ADDENDUM NO. 01 (Date: June 27, 2022)

Fairhope Sewer Upgrade Phase I

Bid No. 005-22 – Lift Station Rehabilitation

Project: Lift Station Rehabilitation, ADCNR Grant #S1P25-FSU1

SHEET:
11B

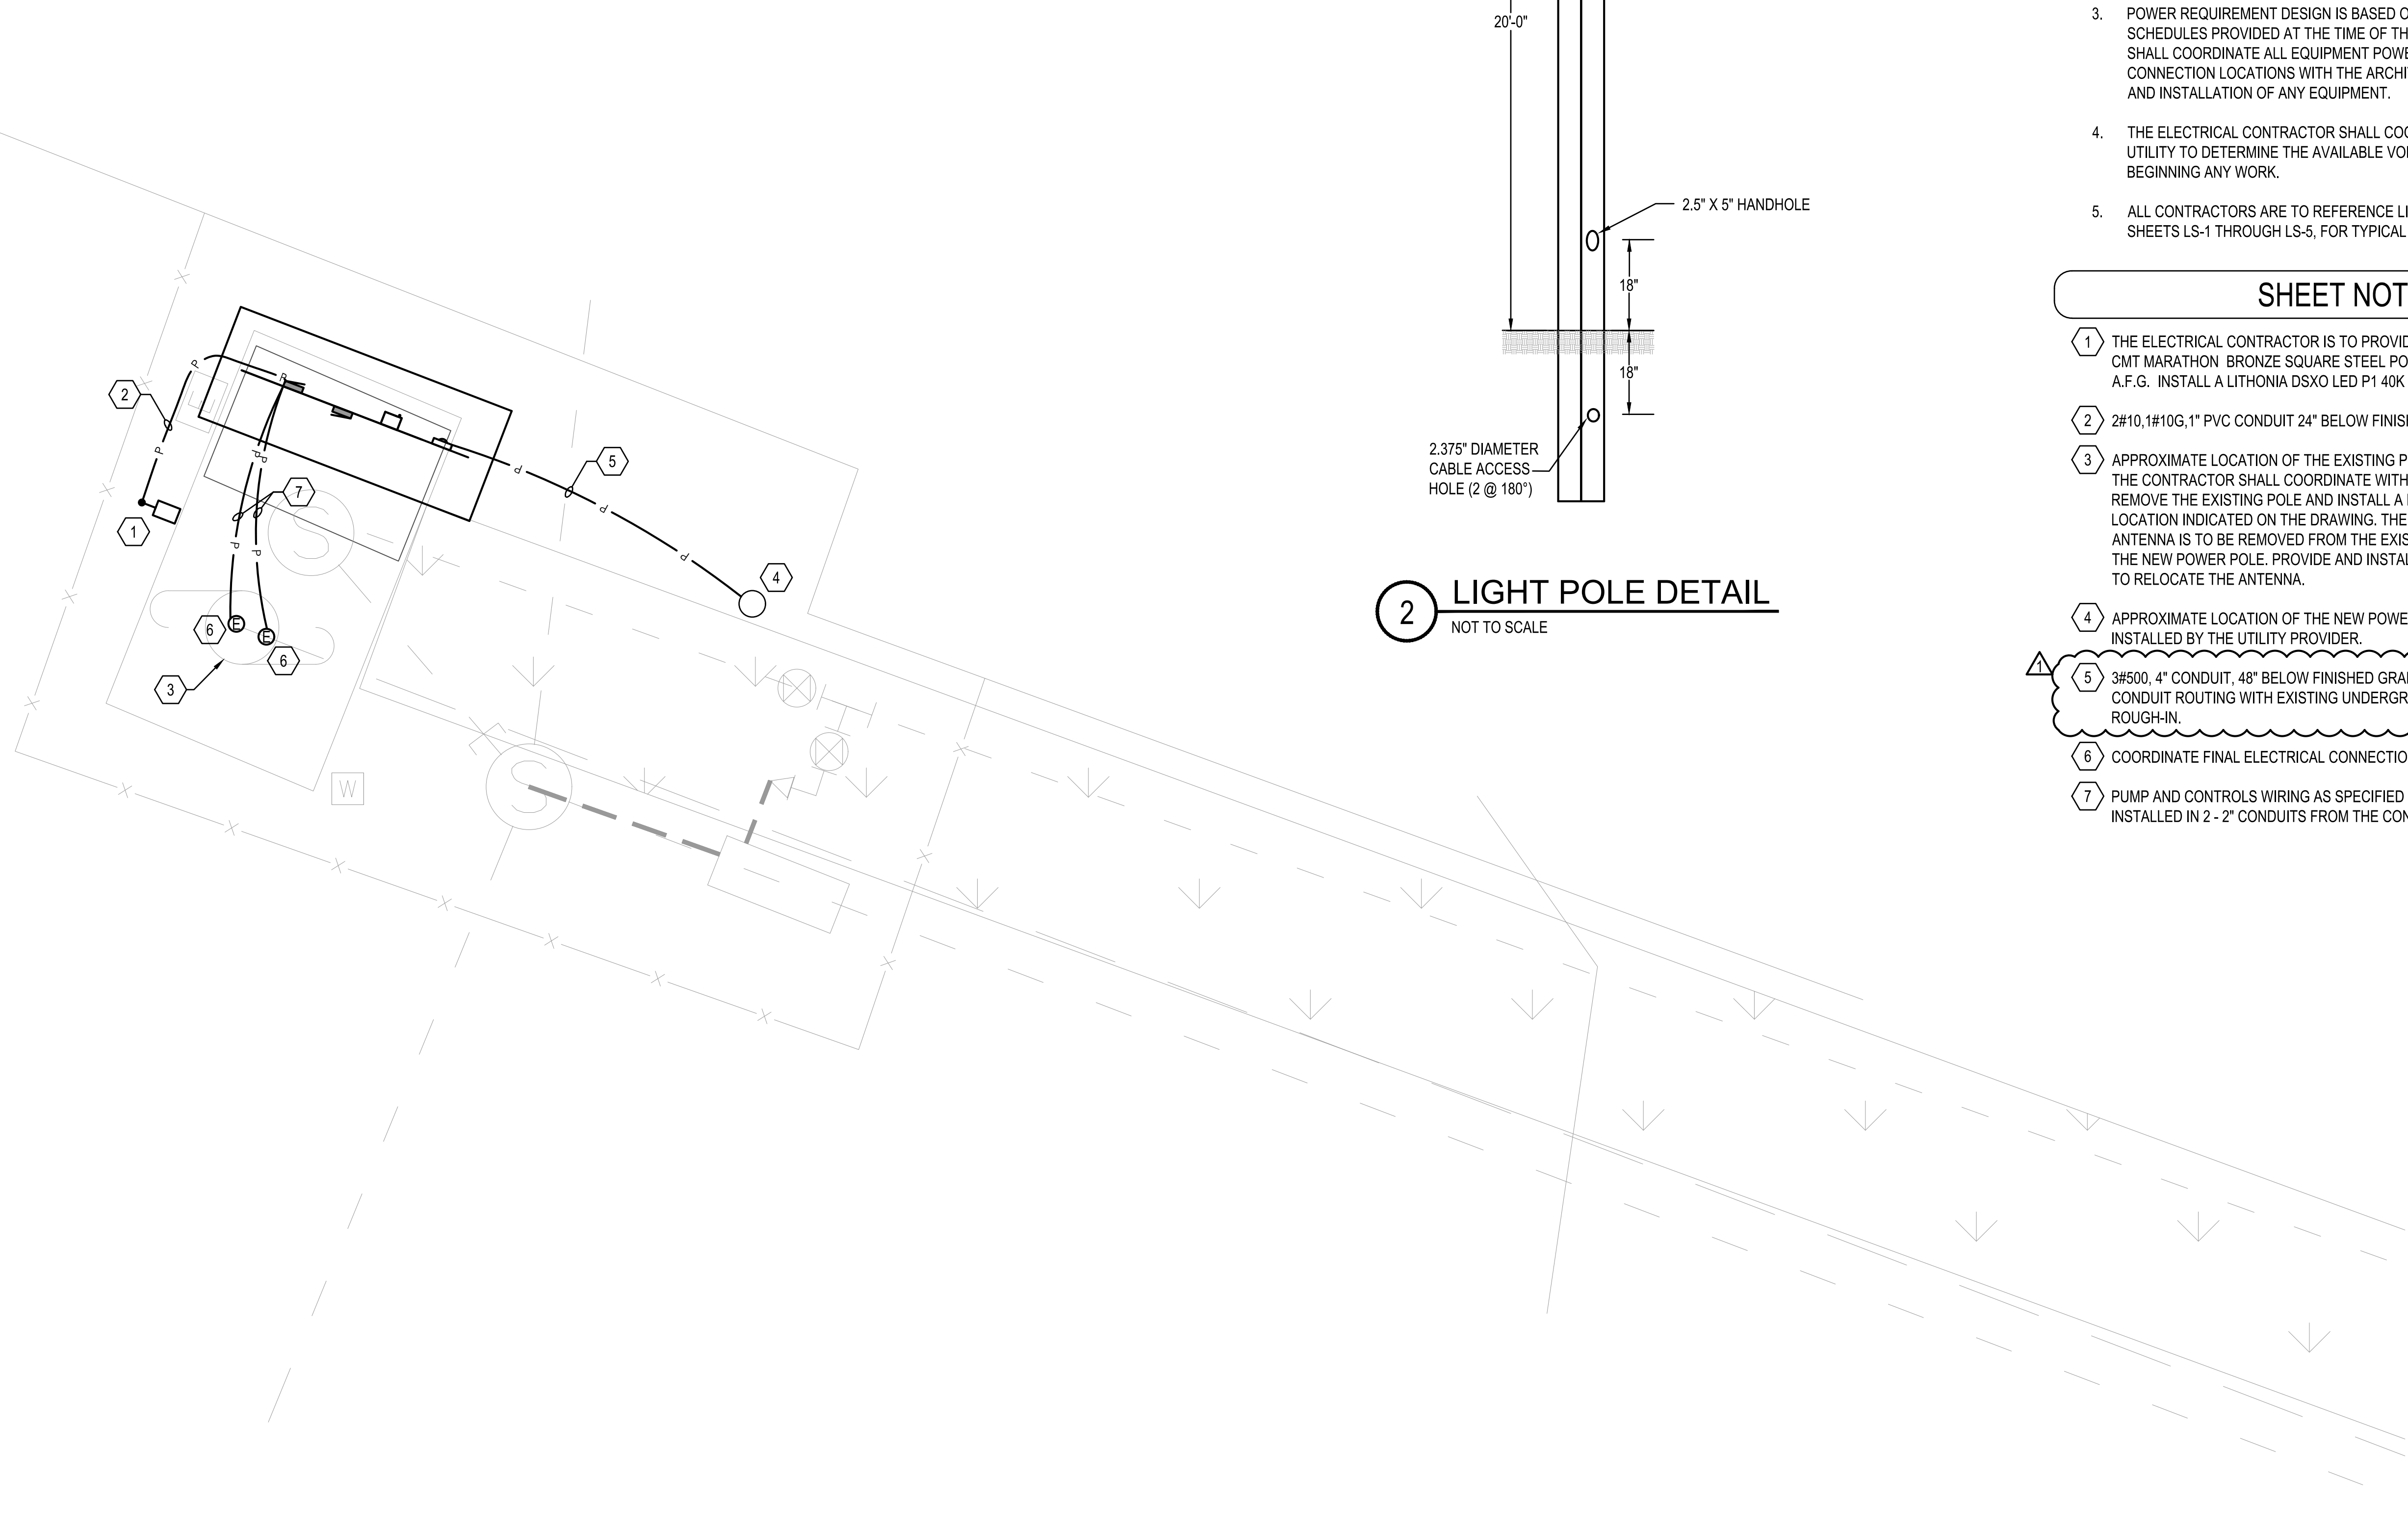
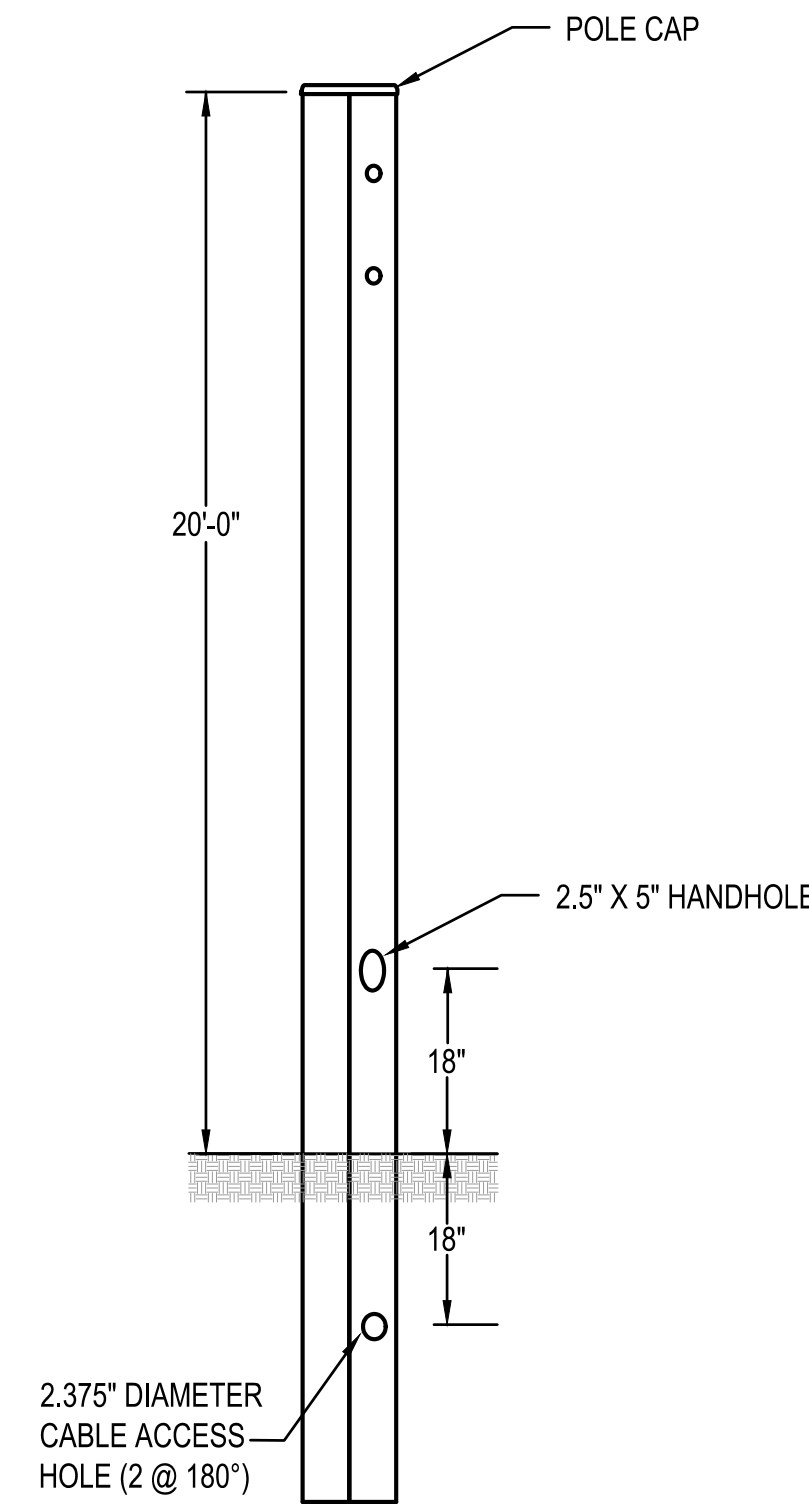
29. **Drawing Amendment:** For the North Mobile Lift Station, provide 3#500, 4" C to feed a 400 Amp control panel (single-phase). This change can be seen on revised plan sheet 11B in Addendum 01. The attached plan sheet will completely replace the previous version (IFB 5/23/22) in its entirety.

- 4 APPROXIMATE LOCATION OF THE NEW POWER POLE PROVIDED AND INSTALLED BY THE UTILITY PROVIDER.
- 5 3#500, 4" CONDUIT, 48" BELOW FINISHED GRADE MINIMUM. COORDINATE CONDUIT ROUTING WITH EXISTING UNDERGROUND UTILITIES PRIOR TO ROUGH-IN.

LIFT STATION SITE PLAN

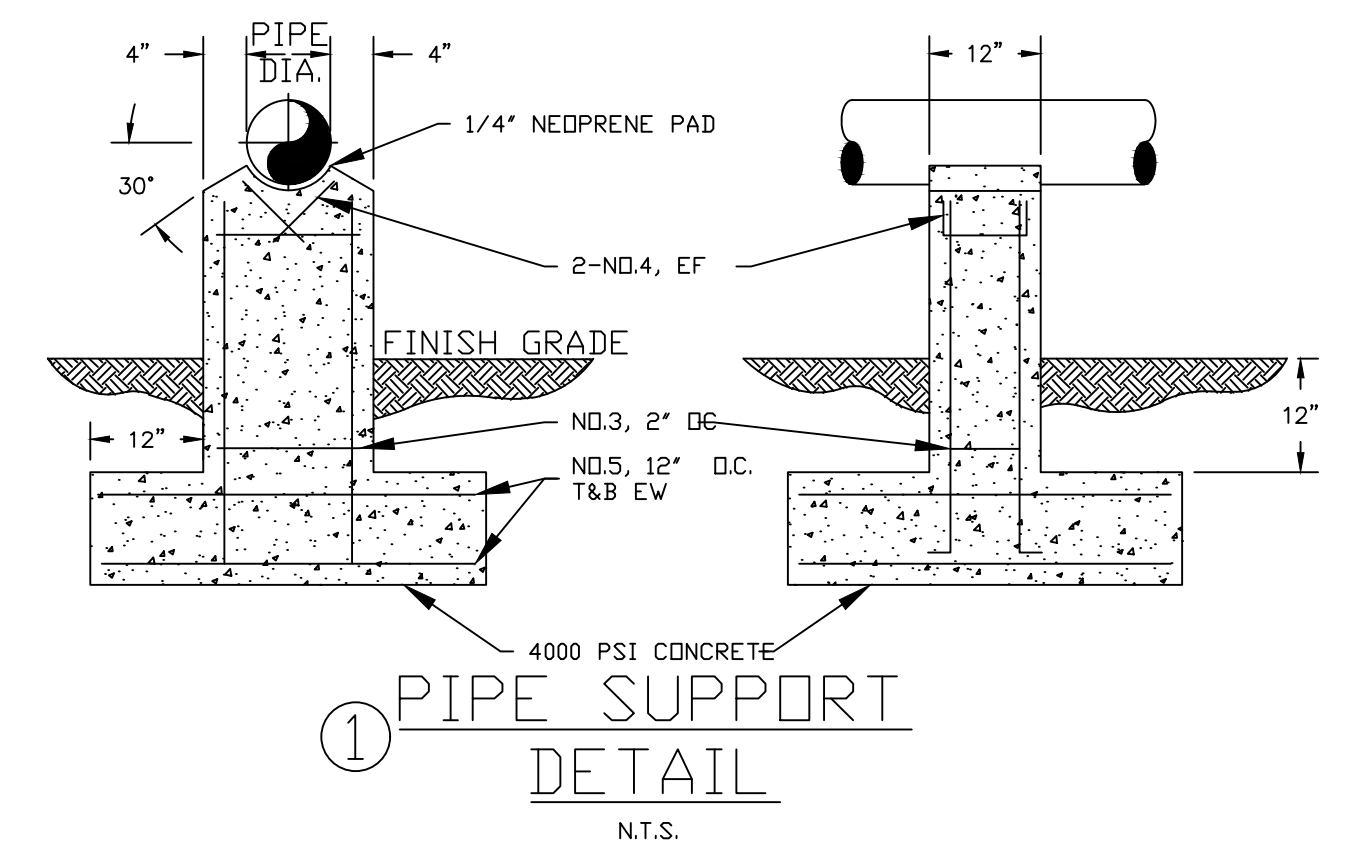
33. Question - Regarding Dwg. 14, Lift Station Site Plan, includes a note regarding 6' high fencing and a gate. Please confirm no fencing is required at any of the sites other than removal/replacement of existing fencing as required at several sites?

36. Question - Dwg. 14, Lift Station Site Plan, includes a note regarding providing compacted limerock base within the perimeter fence. Please confirm this compacted limerock base is not required.

ADDENDUM #01
REVISED NOTES IN LIFT STATION DETAIL (FENCE AND LIMEROCK BASE NOT REQUIRED)

Answer: That is correct. The City will remove and install fences. See revised plan sheet. The attached plan sheet will completely replace the previous version (IFB 5/23/22) in its entirety.

Answer: That is correct. No lime rock aggregate surfacing is required within the lift station area. This plan sheet has been revised. The attached plan sheet will completely replace the previous version (IFB 5/23/22) in its entirety.

④ LIFT STATION METER DETAIL
N.T.S.

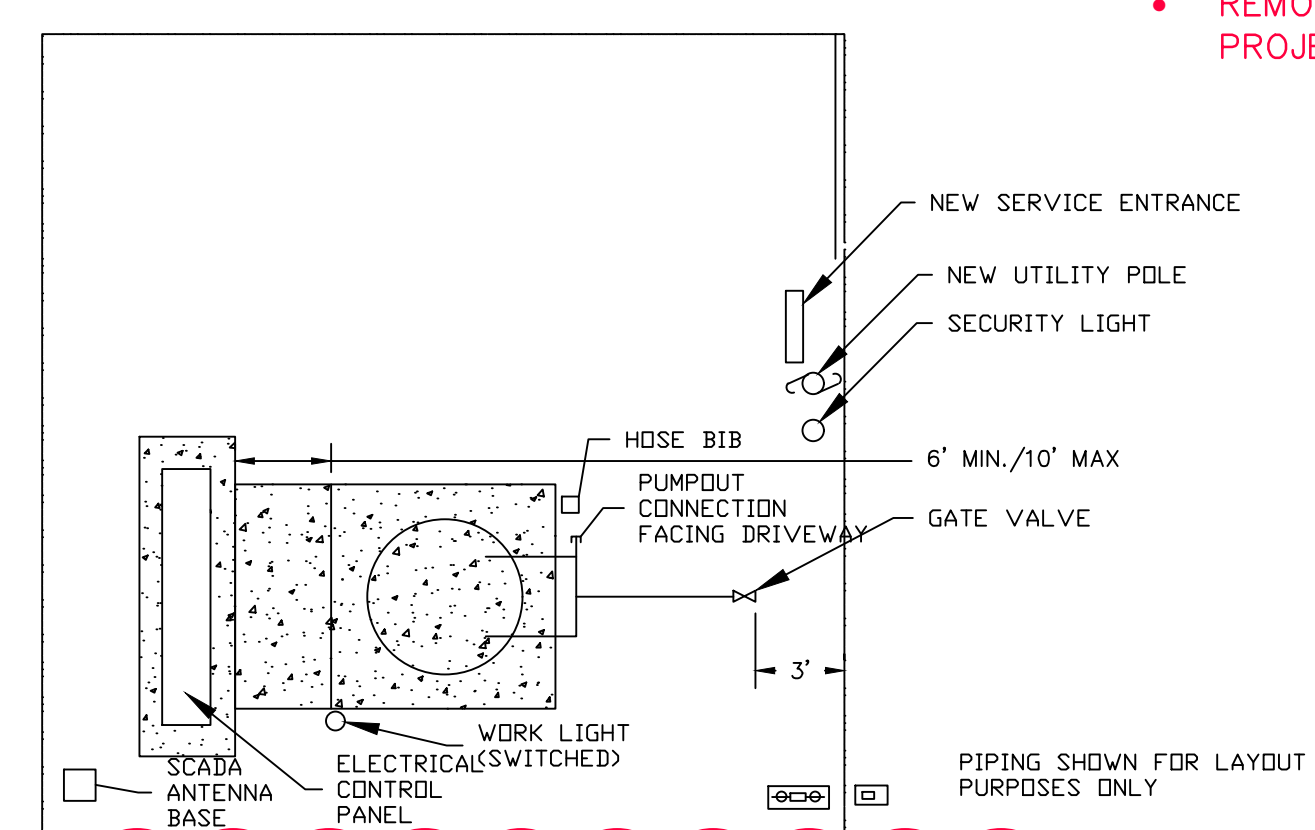
ADDENDUM #01
REMOVED DETAILS 3 AND 4 FROM LIFT STATION DETAILS (DO NOT APPLY TO PROJECT)
